Subject: AP1000 COL Standard Technical Report Submittal of APP-GW-GLN-019, Revision 1
(TR 103)

1. APP-GW-GLN-019, Revision 1, "Fluid System Changes," Technical Report Number 103

WESTINGHOUSE ELECTRIC COMPANY
AP1000 Licensing Design Change Document

Title: Fluid System Changes

Figure 6.2.2-1 (Sheet 1 of 2)
Passive Containment Cooling System
Piping and Instrumentation Diagram
(REF) PCS 001

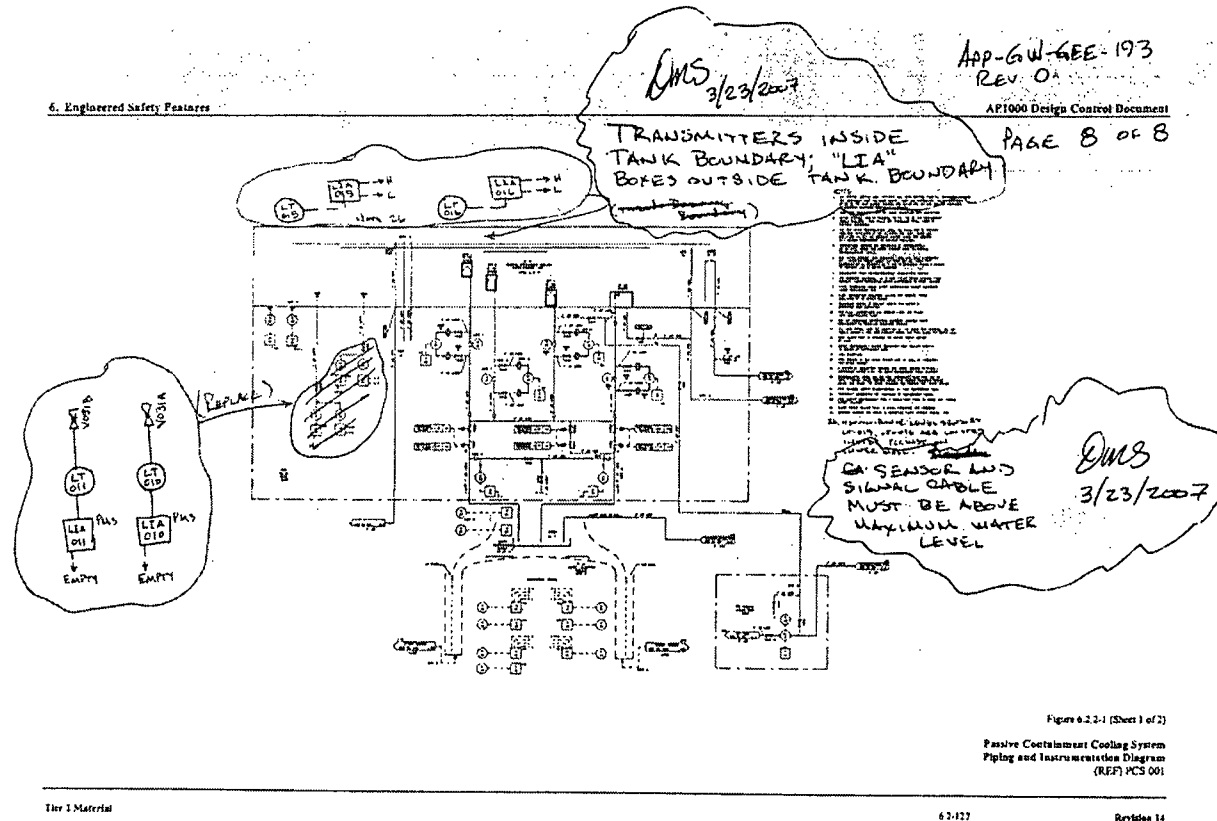
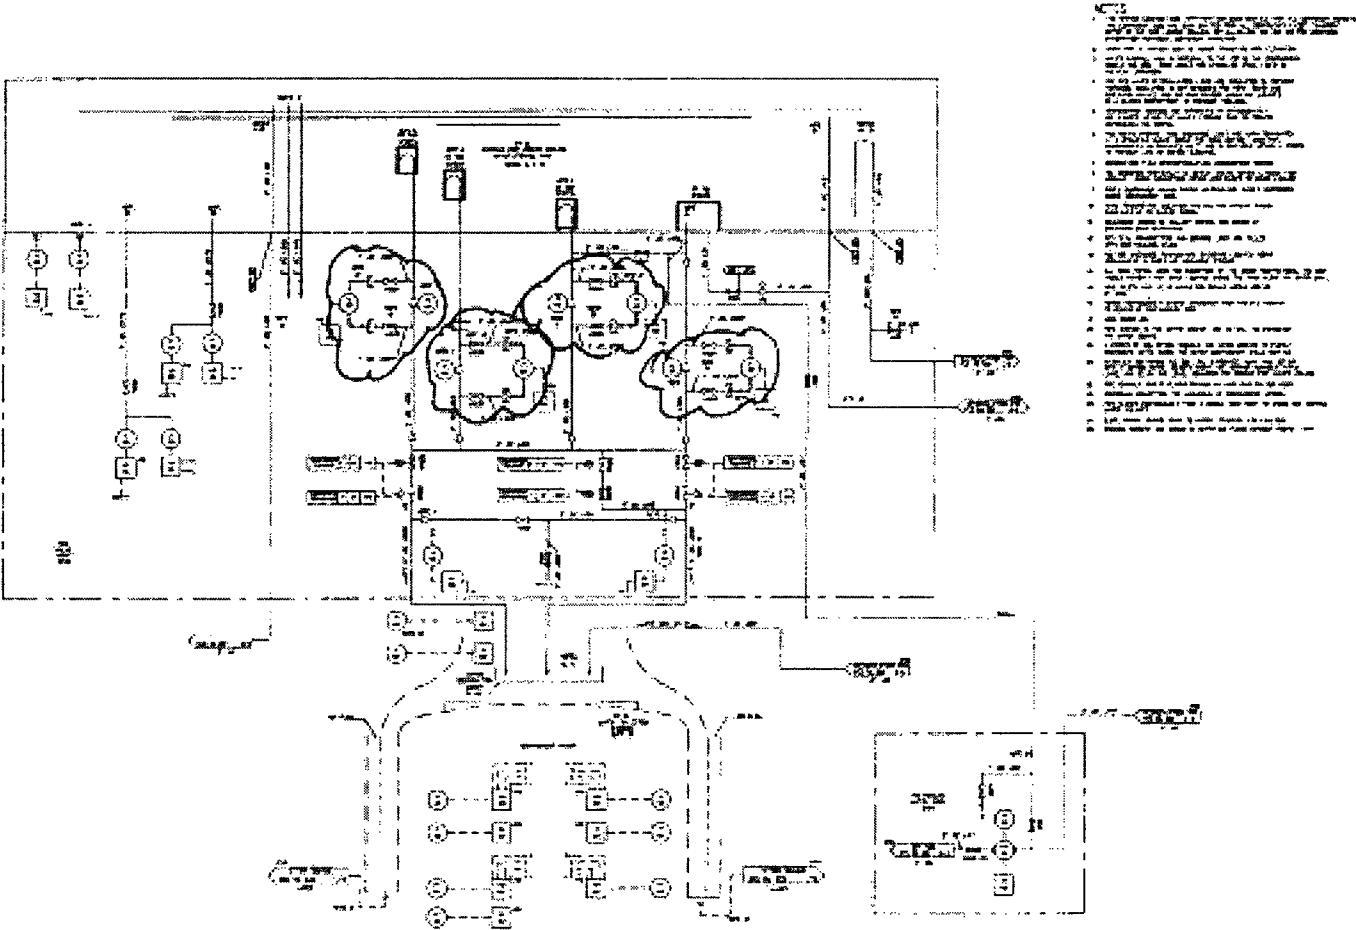
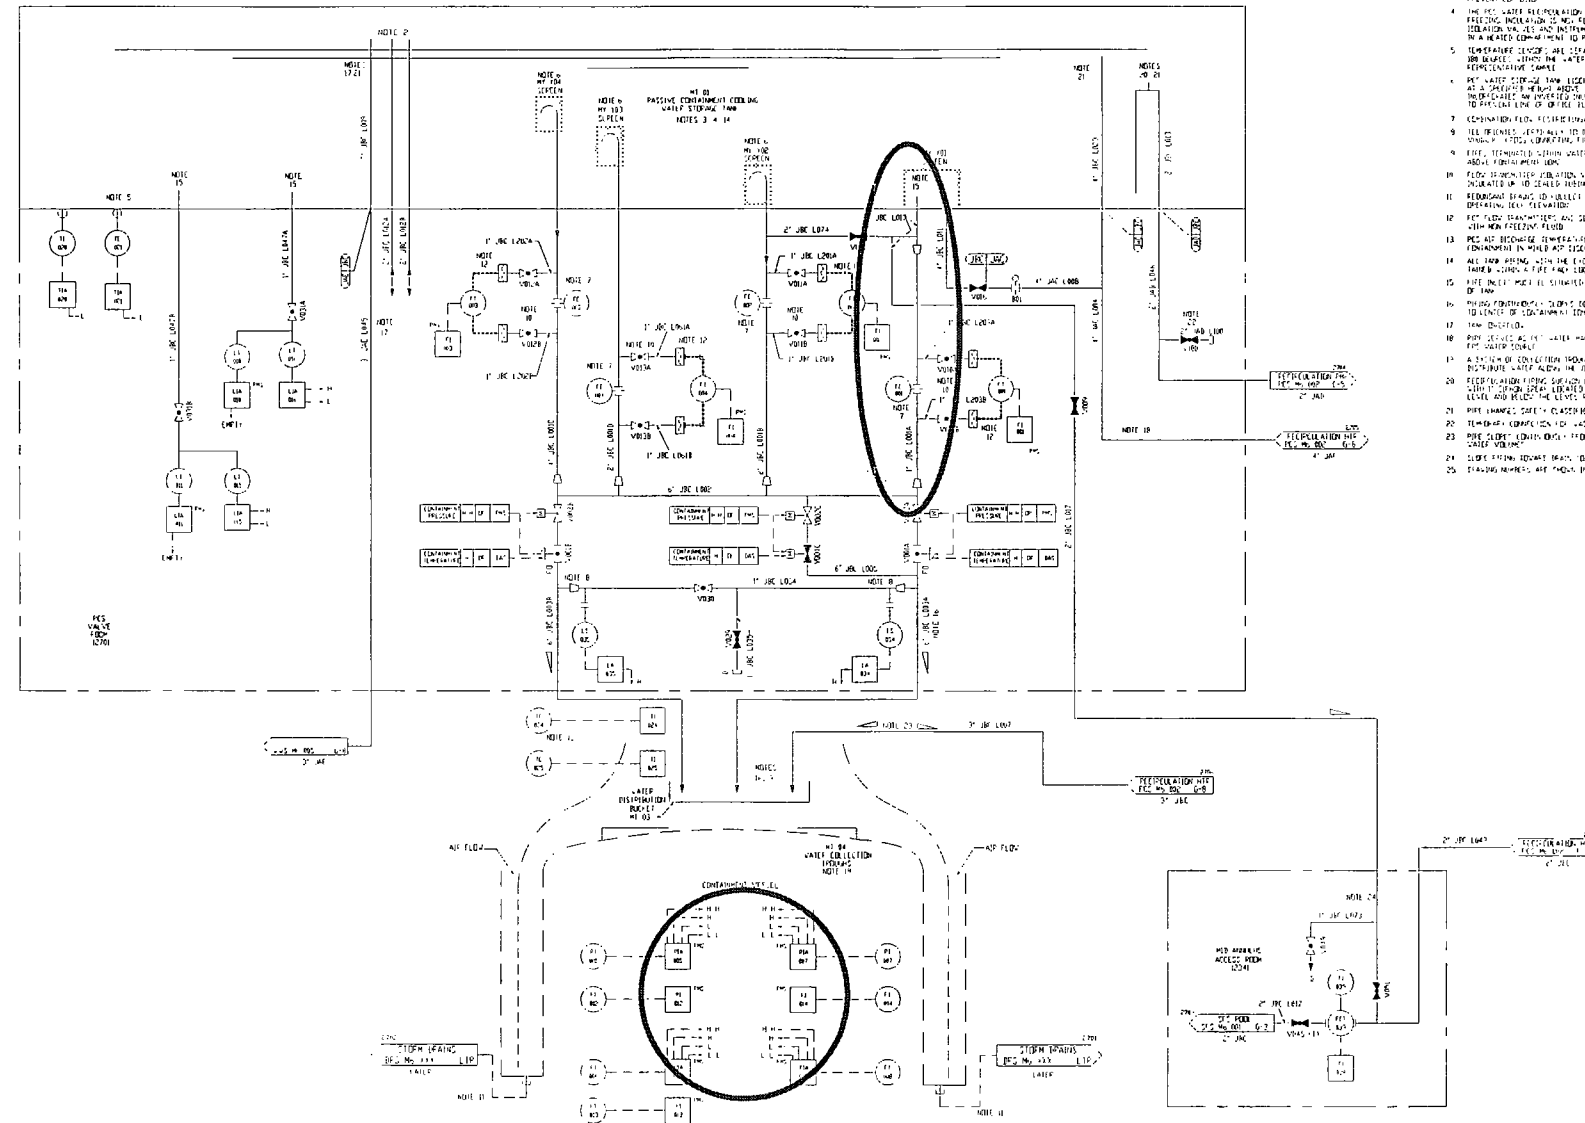
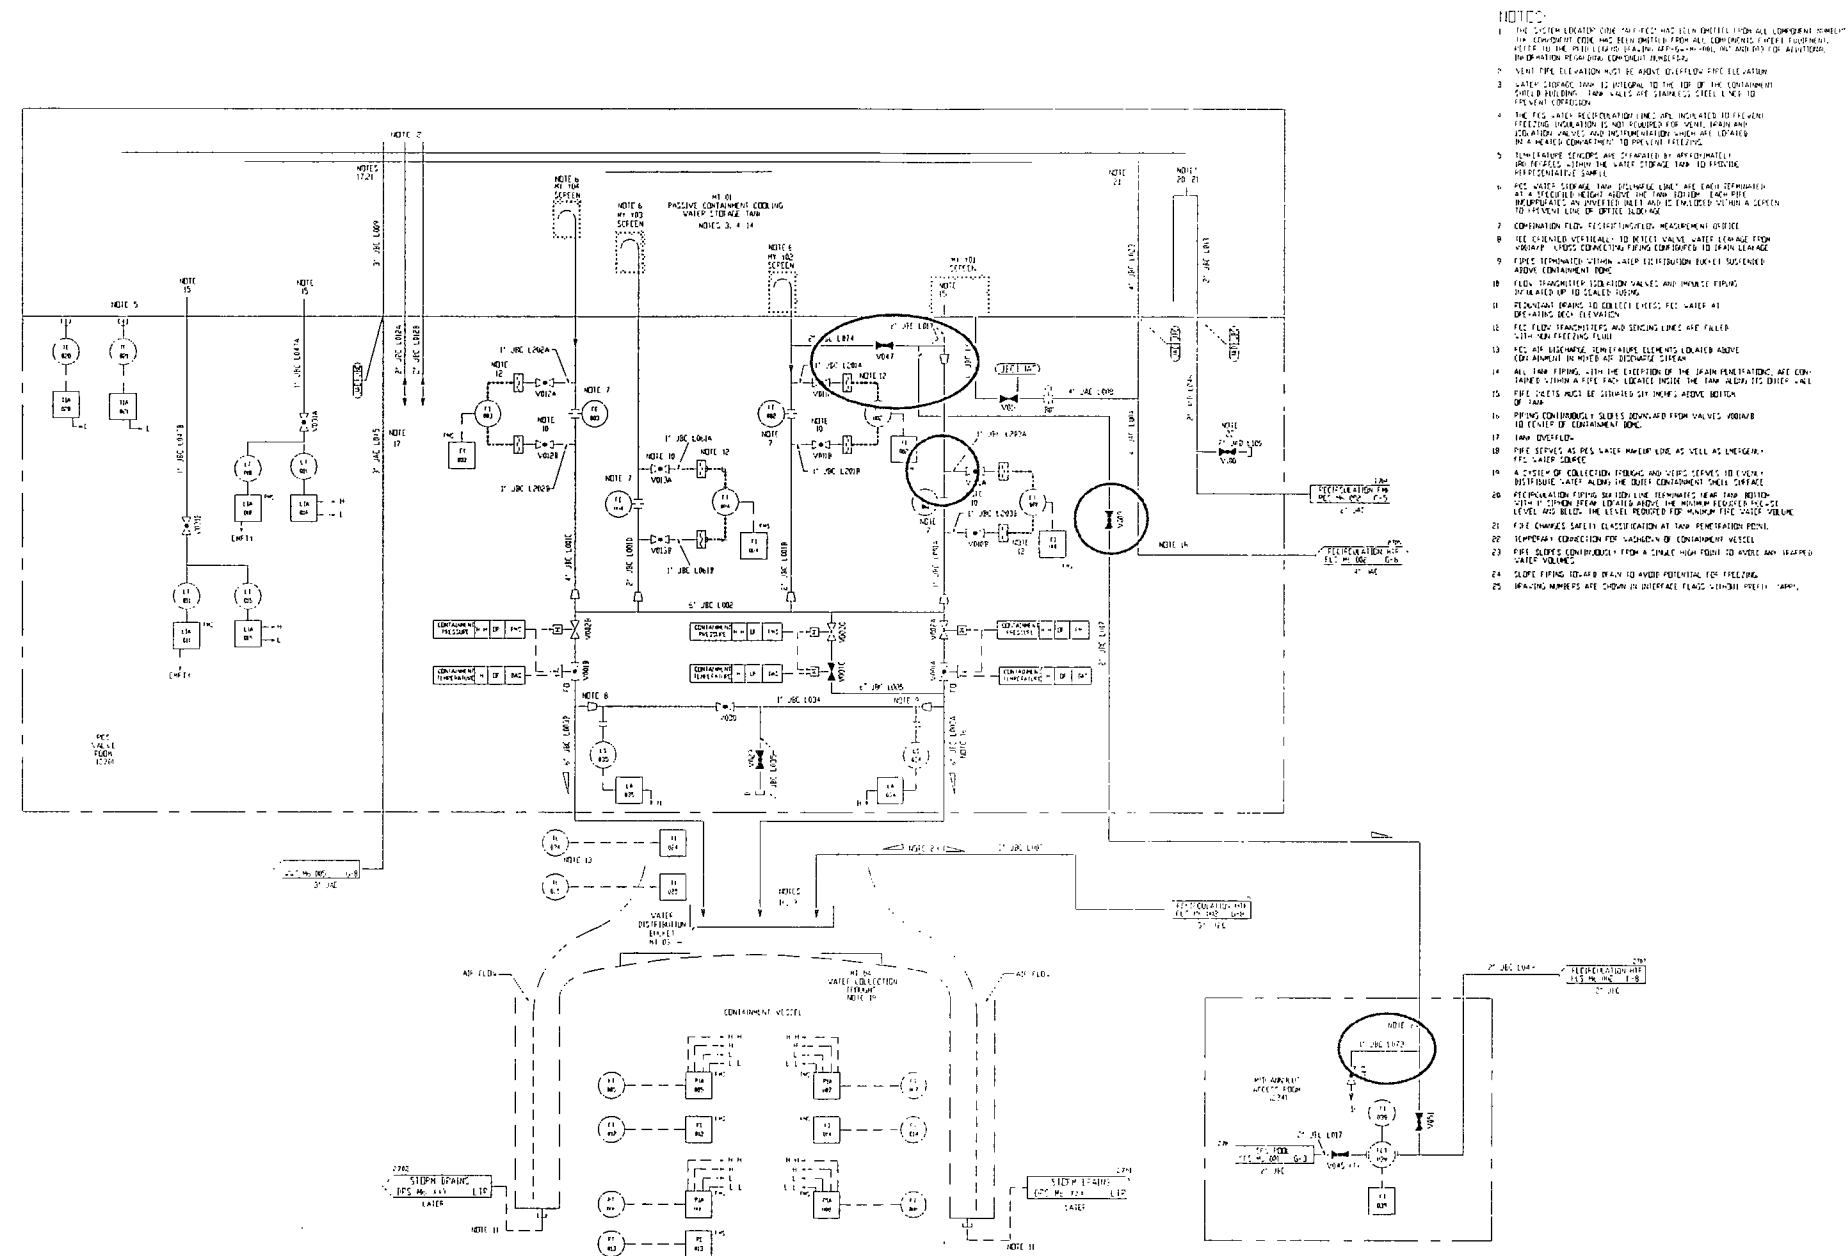
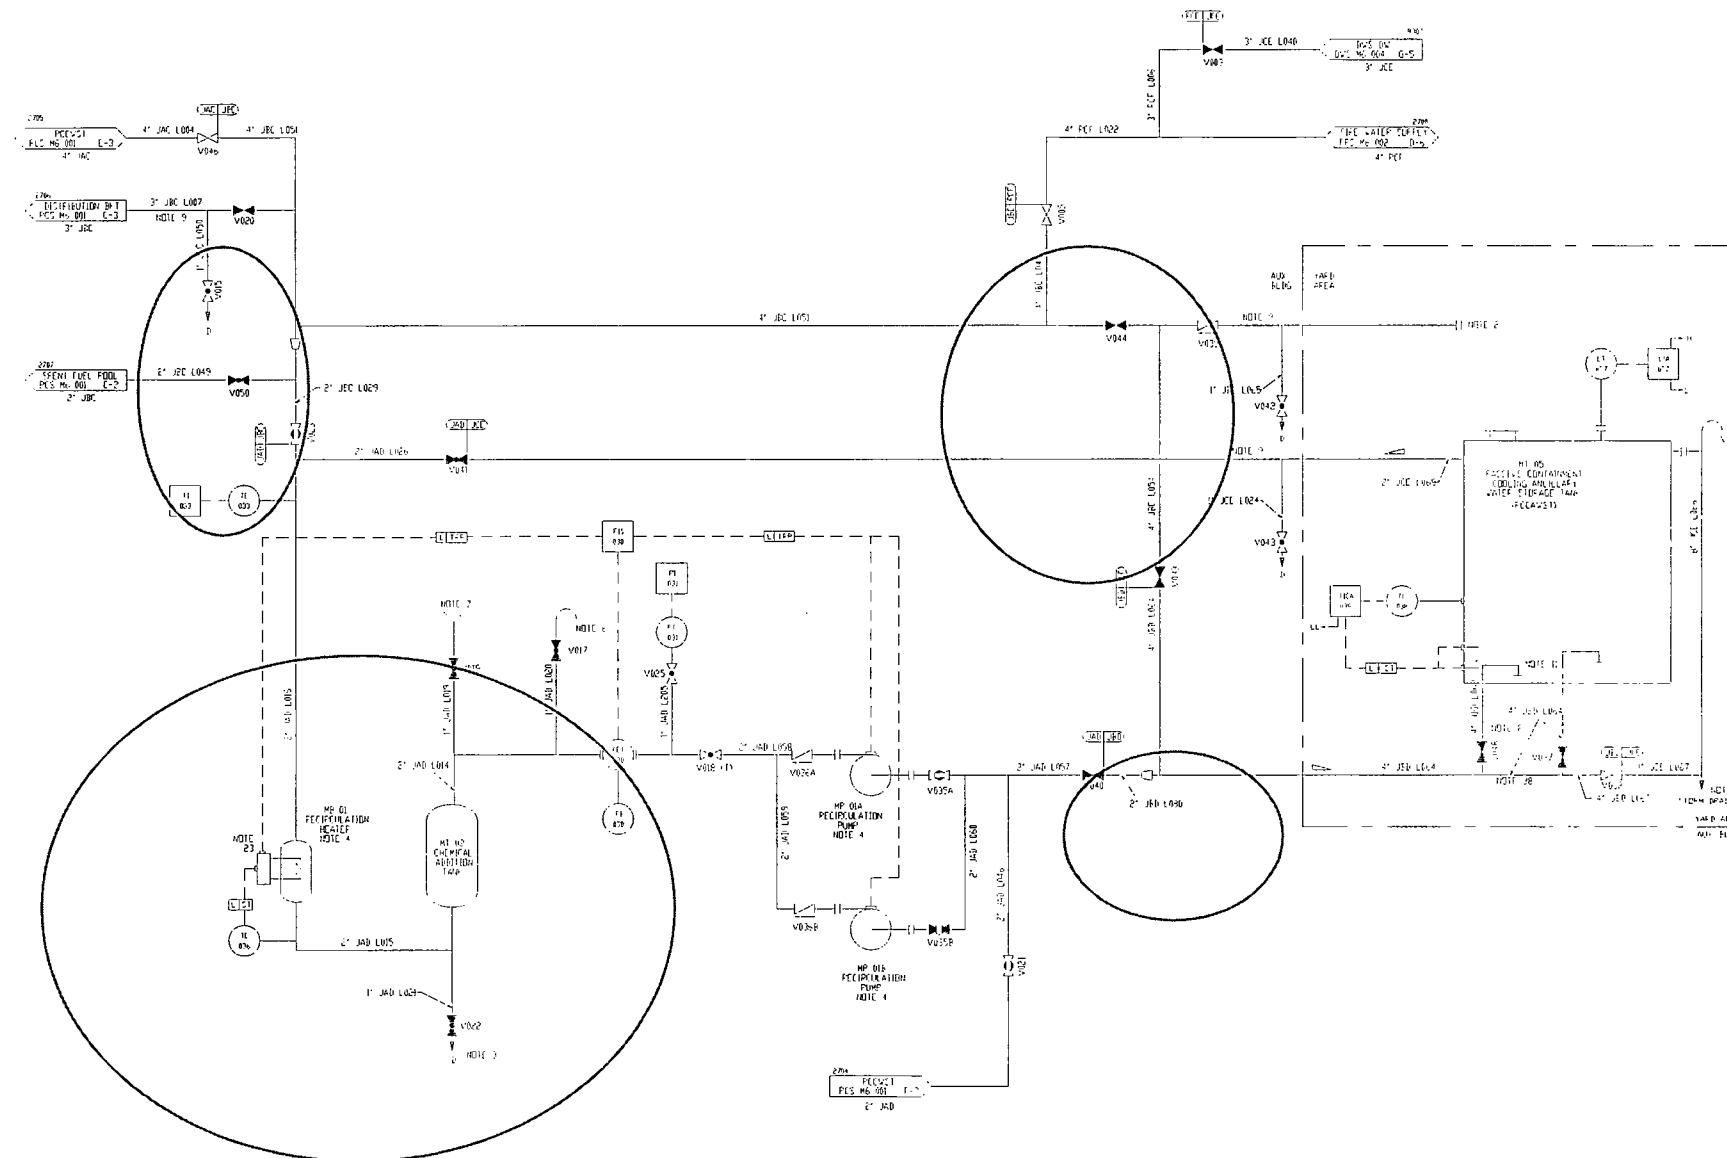
The Passive Containment Cooling System (PCS) P&ID has been updated to reflect the current PCS design. The recirculation heater has been moved upstream of the chemical addition to accommodate a horizontal heater as opposed to a vertical heater. Also, the piping connection to the heater is now flanged instead of welded. The P&ID has also been modified to show the tank's chemical addition line as an independent connection. The tank has separate connections for the chemical additive and water. The P&ID also showed a connection between lines L029 and L051 when no such connection exists in AP1000. Line L029 actually connects to line L048. Finally, the connecting tees between lines L080 and L064, L046 and L057, and L051

Section III contains a markup of changes to DCD Figure 6.2.2-1.
